Amendments to the Drawings

Attached are replacement drawing sheets for amended Figures 1, 2, 3 and 6-10.

Title: TEXT ING SYSTEMS FOR USE IN THREE-DIVISIONAL IMAGING SYSTEMS Inventor(s): Simon PELSON Serial No.: 09/831 241

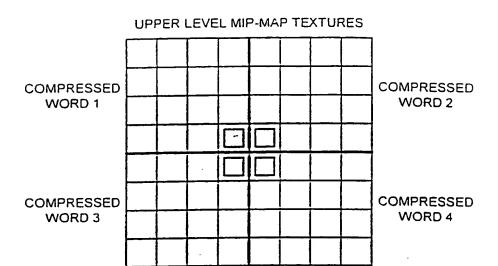
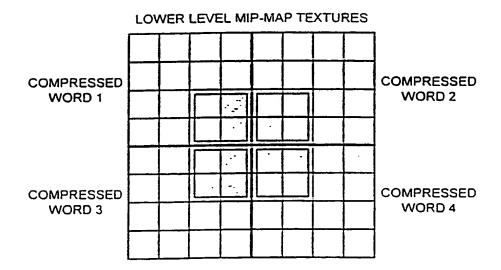
Figure 6A and Figure 6B (Previously Figure 6):
Figure 6 is now relabeled so that the top tile
arrangement is Figure 6A and the bottom tile arrangement is
Figure 6B.

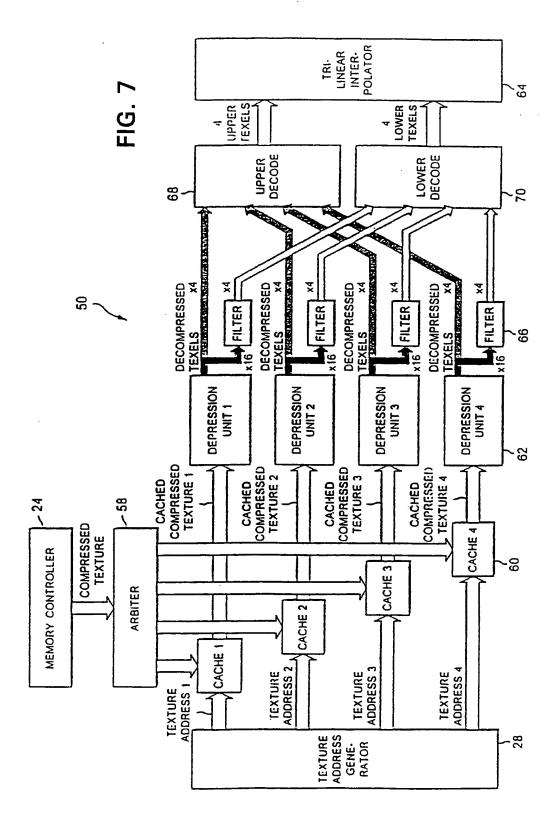
Figure 7:

Partially amend the legend associated with the lower decode unit 70 to the trilinear interpolator 64 from "upper" to "lower". This change is made to make it clear that it is the lower decode unit 70 that provides the low level bits for the trilinear interpolation. (Specification, page 18, line 30 to page 19, line 16).

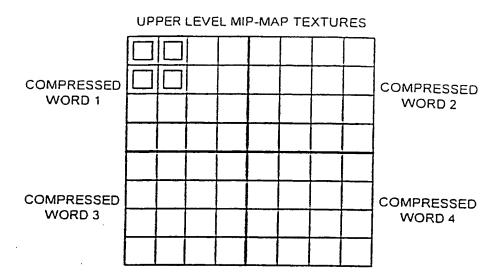
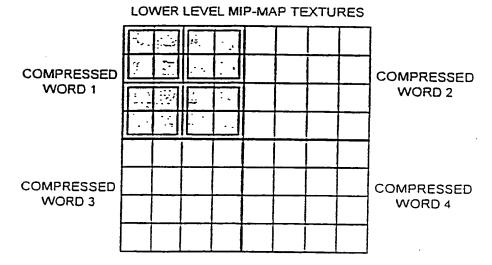
Figure 8A and Figure 8B (Previously Figure 8):

Figure 8 is now relabeled so that the top tile arrangement is Figure 8A and the bottom tile arrangement is Figure 8B.

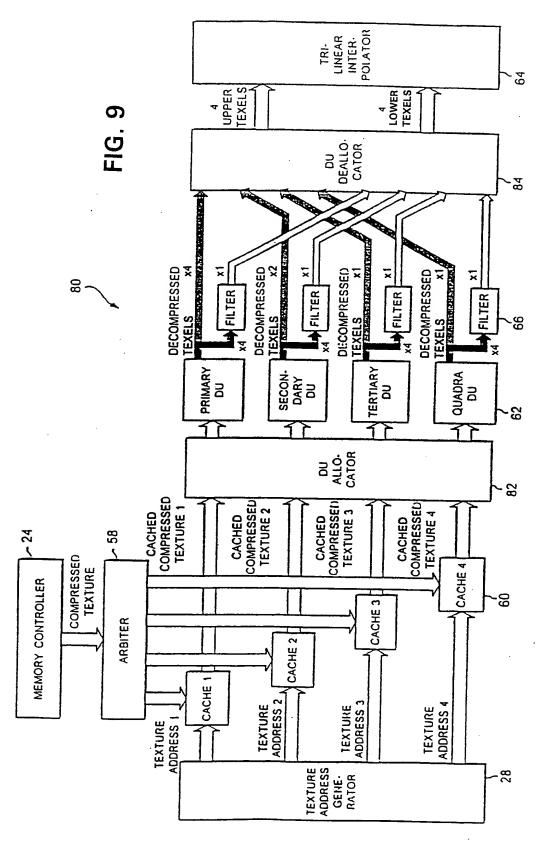
Figures 9 and 10:

Partially amend the legend associated with the lower arrow extending from the DU deallocator 84 to the trilinear

interpolator 64 from "upper" to "lower". This change is intended to make it clear that the DU deallocator 84 supplies both the four upper and four lower texels to the trilinear interpolator. (Specification, page 20, line 33 to page 29, line 3).
